Access Compliance Report

Public Rights-of-Way

(Curb Ramps)

Intersection ID: 20061	Main Street: S_TRYON_ST	Cross Street: YORKHILLS_DR	Location: SE
ADA ID: 355AE5F7FA36	Ramp Type: PerpDiag	Initial Pass/Fail: Fail	Overall Compliance: No
Codes/Mitigation Info/Possible Solution		Field Measurements/Component Compliance

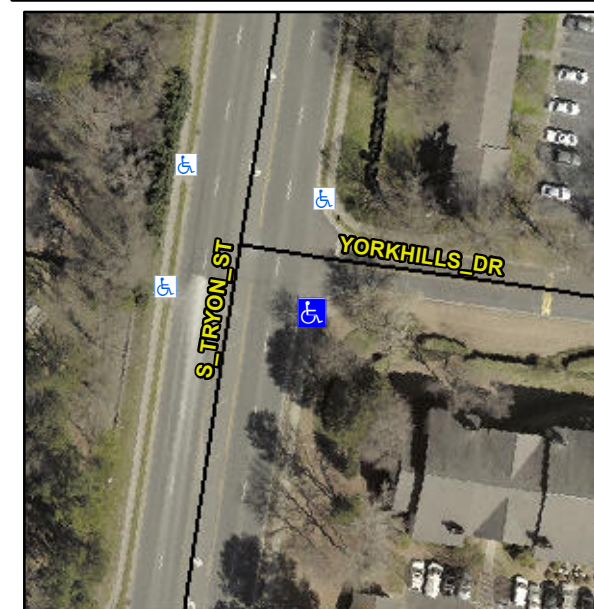
Not Found, R304.2.2, R304.5.3

Compliance	Description	Data	Compliance	Description	Data
N/A	Ramp Length (in)	90.0	No	Ramp Slope (%)	10.4
Yes	Ramp Width (in)	54.0	No	Ramp XSlope (%)	4.7
N/A	Flare Type LT	N/A	N/A	Flare Type RT	N/A
N/A	Flare Slope LT (%)	N/A	N/A	Flare Slope RT (%)	N/A
N/A	Flare Traversable LT?	N/A	N/A	Flare Traversable RT?	N/A
N/A	Landing Length (in)	N/A	N/A	DWS Provided?	N/A
N/A	Landing Width (in)	N/A	N/A	DWS Contrast?	N/A
N/A	Landing Slope (%)	N/A	N/A	DWS Length (in)	N/A
N/A	Landing X Slope (%)	N/A	N/A	DWS Full Width?	N/A
N/A	Landing Curb? (Y/N)	N/A	N/A	DWS Offset (in)	N/A
N/A	Shared Landing?	N/A			
N/A	Gutter Ponding?	N/A	N/A	Gutter Slope (%)	N/A
N/A	Gutter Lip Ht (in)	N/A	N/A	Gutter X Slope (%)	N/A
N/A	Painted X Walk1?	No	N/A	Painted X Walk2?	No
	X Walk 1 Direction	To N		X Walk 2 Direction	To W
N/A	X Walk 1 Width (in)	N/A	N/A	X Walk 2 Width (in)	N/A
	X Walk 1 Slope (%)	5.6		X Walk 2 Slope (%)	4.1
	X Walk 1 X Slope (%)	2.1		X Walk 2 X Slope (%)	6.4

Remove & Replace Curb Ramp With Two New Directional Ramps or Equivalent.
